WESTGATE, KEMPS CREEK (SSD-23480429) | INTERIM RESPONSE TO SUBMISSIONS

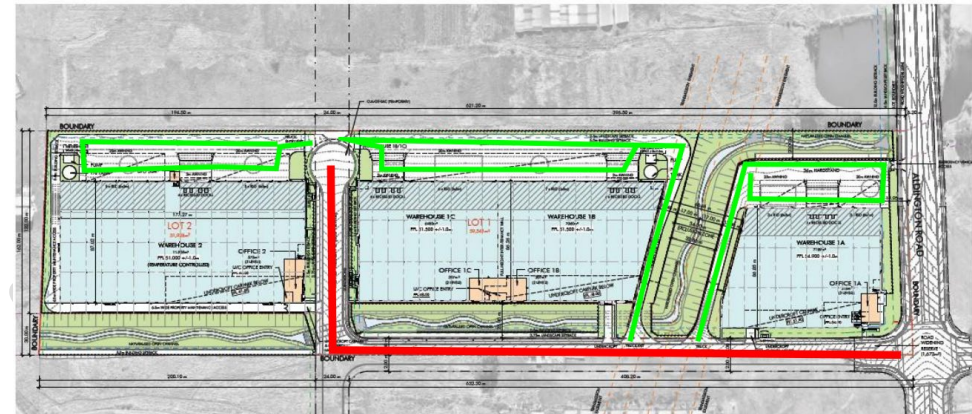
Item	Issue	Response
		<p><i>Noise modelling has considered the anticipated worst case for the day, evening and night assessment periods. As outlined in Section 4.2.2 Page 32 of the NVIA v4 the assessment considered the PEAK 1hr truck movements within each assessment period and then considered that number broken down into a relative 15-minute assessment period as required. The context of the NVIA also confirms that truck movements outside of these peak periods are significantly lower. The assessment has also considered a full changeover of carpark for light vehicles, continuous use of fork trucks external and continuous operation of the specified mechanical plant.</i></p> <p><u>DPHI Response / Heavy Vehicle Movement 04.02.2025</u> <i>The noise modelling shows the main contributor to noise is heavy vehicle movements. Please present a scenario that excludes heavy vehicle noise sources on public roads to confirm compliance with the project amenity noise levels and for deriving achievable night-time noise limits (eg. with truck movement sources = 31dBA at Mount Vernon, without truck movement sources= 27dBA).</i></p> <p><u>DPHI Response / Light Vehicle Movement 04.02.2025</u> <i>Review the assumption for the usage of car park at night to give us a more realistic set of noise predictions. The model currently assumes that the car park is fully utilised at night, which may not be realistic (e.g. without truck movement and car park sources = 26 dBA).</i></p> <p><u>Applicant Response / Heavy Vehicle Movement 07.02.2025</u> <i>Please find a mark-up site plan which identifies the heavy vehicle movements across the estate roads (in red, to be excluded in modelling scenario) and heavy vehicle movements across the warehouse driveways and loading dock/hardstand areas (in green, to be included in modelling scenario). Can you please confirm that this would satisfy the scenario modelling you have requested and EMM will update the NVIA accordingly.</i></p>

-  Exclude all HV movements and LV on these Routes / Roads
-  Retain / Include all HV movements on these Routes / Site

EMM have modelled the scenario where there is no use of the carpark and light vehicles at night. This scenario modelling found that no carpark and light vehicle use at night this results in a reduction of <0.1dB. This saving is considered to result in negligible impact. In the instance there is partial use of the carpark and light vehicles at night (e.g. 50% utilization), the acoustic saving will be even less.

Yes this is fine. Please update NVIA

Noted. No need to update modelling assumptions.

An updated NVIA (**Appendix G**) has been prepared which updated the modelling in accordance with the above with new assumptions for site in terms of truck movements on public roads

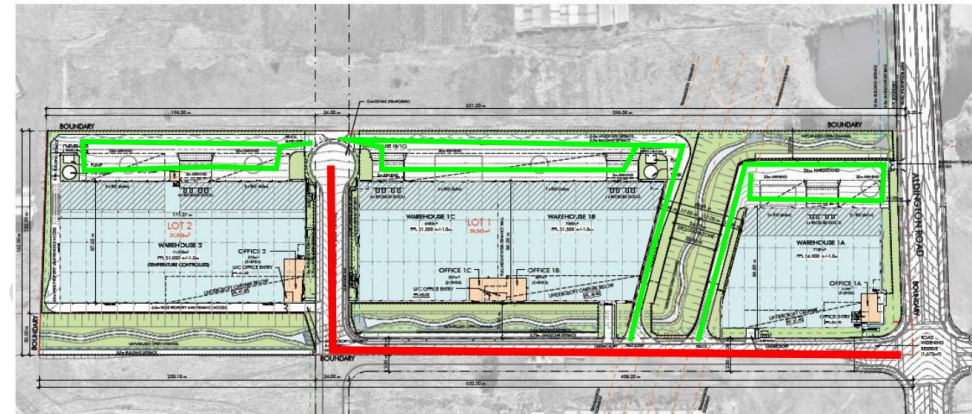
Item	Issue	Response
	reference sites for large format and retail facilities that may be more appropriate for use as benchmark sites for this assessment.	<p>DPHI Response 21.01.2025 <i>noise generation modelling should reflect worst case scenario for loading docks, reflecting the docks being close-to or at-capacity. We need to ensure this is as realistic as possible and reflects worse case operational scenarios</i></p> <p>Applicant Response 03.02.2025 <i>Noise modelling has considered the anticipated worst case for the day, evening and night assessment periods. As outlined in Section 4.2.2 Page 32 of the NVIA v4 the assessment considered the PEAK 1hr truck movements within each assessment period and then considered that number broken down into a relative 15-minute assessment period as required. The context of the NVIA also confirms that truck movements outside of these peak periods are significantly lower. The assessment has also considered a full changeover of carpark for light vehicles, continuous use of fork trucks external and continuous operation of the specified mechanical plant.</i></p> <p>DPHI Response / Heavy Vehicle Movement 04.02.2025 <i>The noise modelling shows the main contributor to noise is heavy vehicle movements. Please present a scenario that excludes heavy vehicle noise sources on public roads to confirm compliance with the project amenity noise levels and for deriving achievable night-time noise limits (eg. with truck movement sources = 31dBA at Mount Vernon, without truck movement sources= 27dBA).</i></p> <p>DPHI Response / Light Vehicle Movement 04.02.2025 <i>Review the assumption for the usage of car park at night to give us a more realistic set of noise predictions. The model currently assumes that the car park is fully utilised at night, which may not be realistic (e.g. without truck movement and car park sources = 26 dBA).</i></p> <p>Applicant Response / Heavy Vehicle Movement 07.02.2025 <i>Please find a mark-up site plan which identifies the heavy vehicle movements across the estate roads (in red, to be excluded in modelling scenario) and heavy vehicle movements across the warehouse driveways and loading dock/hardstand areas (in green, to be included in modelling scenario). Can you please confirm that this would satisfy the scenario modelling you have requested and EMM will update the NVIA accordingly.</i></p>

Exclude all HV movements and LV on these Routes / Roads
 Retain / Include all HV movements on these Routes / Site

EMM have modelled the scenario where there is no use of the carpark and light vehicles at night. This scenario modelling found that no carpark and light vehicle use at night this results in a reduction of <0.1dB. This saving is considered to result in negligible impact. In the instance there is partial use of the carpark and light vehicles at night (e.g. 50% utilization), the acoustic saving will be even less.

Yes this is fine. Please update NVIA

Noted. No need to update modelling assumptions.

An updated NVIA (**Appendix G**) has been prepared which updated the modelling in accordance with the above with new assumptions for site in terms of truck movements on public roads.

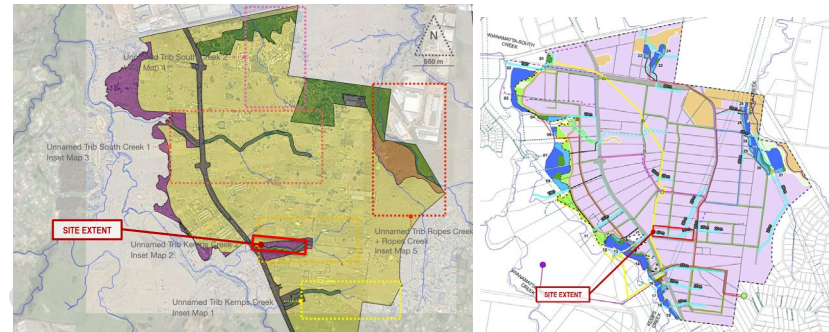
Water		
11	<p>The Department notes a Strahler order 2 waterway is identified on-site. Please demonstrate consistency with Section 2.3 of the MRP DCP in relation to the ongoing management and maintenance of riparian land.</p>	<p>As per the <i>Mamre Road Precinct Waterway Assessment</i> (CTEnvironmental, April 2020), contained in the <i>Mamre Road Flood, Riparian Corridor, and Integrated Water Cycle Management Strategy</i> (Sydney Water, October 2020), the mapping shows a Strahler order 2 waterway running through the site. Subsequently, the MRP DCP and Sydney Water identified indicative locations of trunk drainage infrastructure, which includes a trunk drainage corridor that runs along the same, general location as the Strahler order 2 waterway (refer to the below). Extract of waterway mapping (Left) and Mamre Road Precinct Stormwater Scheme Plan (Right)</p>

As part of this project, a trunk drainage channel is proposed to form part of the broader water management strategy within the Mamre Road Precinct. This trunk drainage channel is approved in principal by Sydney Water.

As such, while the development will not maintain the Strahler Order 2 waterway in its natural state, as per Section 2.3 of the MRP DCP, the development seeks to achieve the relevant water quality and flow-related objectives in collaboration with Sydney Water, and consistent with the general alignment for a trunk drainage channel, as identified in the MRP DCP. Consistent with Sydney Water's Stormwater Scheme Plan (May 2024), the proposed development of Westgate Kemps Creek will incorporate a naturalised trunk drainage channel, for which design development has been undertaken with Sydney Water to reach a mutually agreeable corridor width, which varies between 20 metres and 32 metres throughout the site.

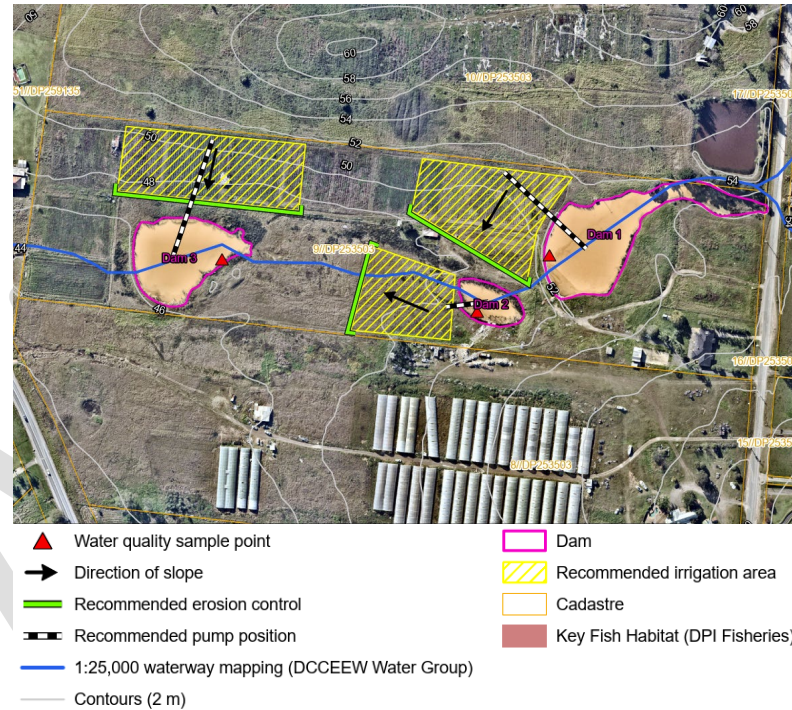
Scape Design has prepared a Landscape Masterplan and Planting Plan for the naturalised trunk drainage corridor (Appendix I of the November 2024 Submissions Report). As seen in the image below, the bulk of the waterway, outside of the farm dams, are comprised of cleared grasslands. As such, the proposal aligns with the objectives of Section 2.3 of the MRP DCP.

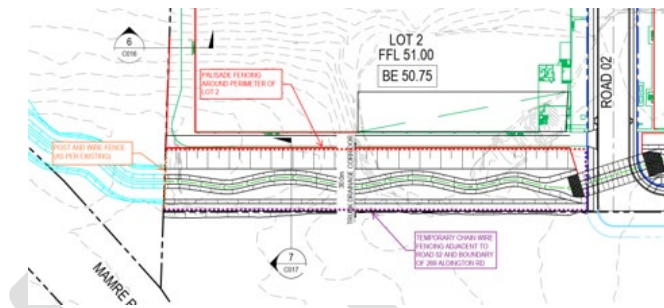
13	<p>The Submissions Report (Item 11, page 45) notes that in the event the downstream trunk drainage channel is not constructed at the time that the development commences operation, the trunk drainage channel would pond to a maximum of 1.2 m. Provide details of the safety measures (e.g. safety signage, fencing) that would be in place</p>	<p>Fencing will be installed adjacent to the trunk drainage channel to prevent access by the general public. Please refer to the sketch showing the proposed fencing types that would be adopted prior to completion of the trunk drainage channel downstream of Westgate Kemps Creek. The exact types of fencing will be the subject of further detailed design coordination with Sydney Water and Penrith City Council.</p>

to prevent unauthorised access to the channel from members of the public or visitors to the estate.

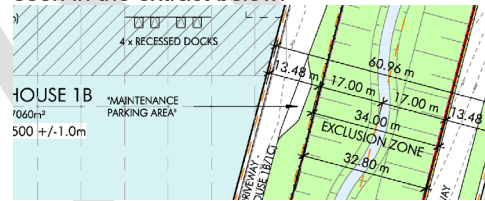
15	Update the architectural plans to show the proposed parking pad that would provide access to the Transgrid easement.	The architectural plans have been updated to show the "maintenance parking area" located adjacent to the Warehouse 1B/1C driveway and riparian corridor (Appendix F) as seen in the extract below.
----	--	---

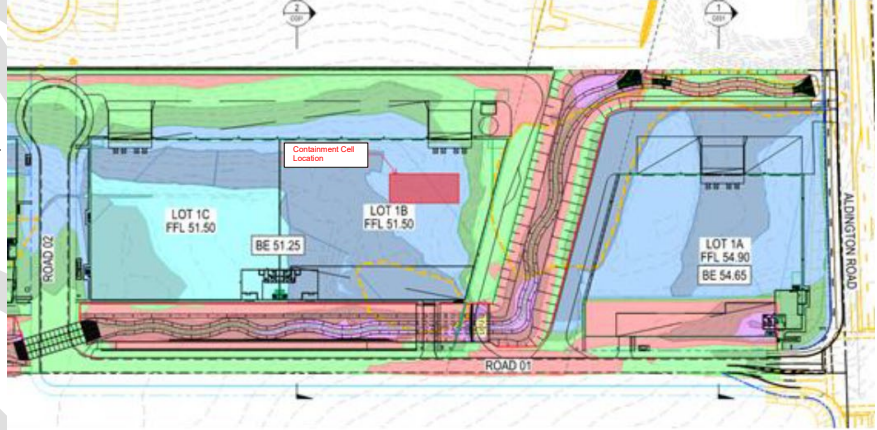
4a	<p>The proposal includes works within the adjoining property to the south for the intersection at Aldington Road. The applicant should engage with the neighbouring property developers regarding the delivery of the intersection at 253-267 Aldington Road.</p>	<p>Noted.</p> <p>The intersection is being coordinated and will continue to be coordinated between the two landowners, Icon Oceania and Anric Group.</p>
4b	<p>Use of Bakers Lane by development traffic should be prohibited.</p>	<p>Noted, use of Bakers Lane by development traffic is not proposed as part of this SSDA.</p>
4c	<p>Operation of the site shall not commence until the road upgrades are delivered.</p>	<p>It is agreed that the suitable conditions stipulating that site intersection upgrades must be completed in accordance with 1000 Series, SSD-10479-Mod 3, prior to any Occupation Certificate being issued.</p>
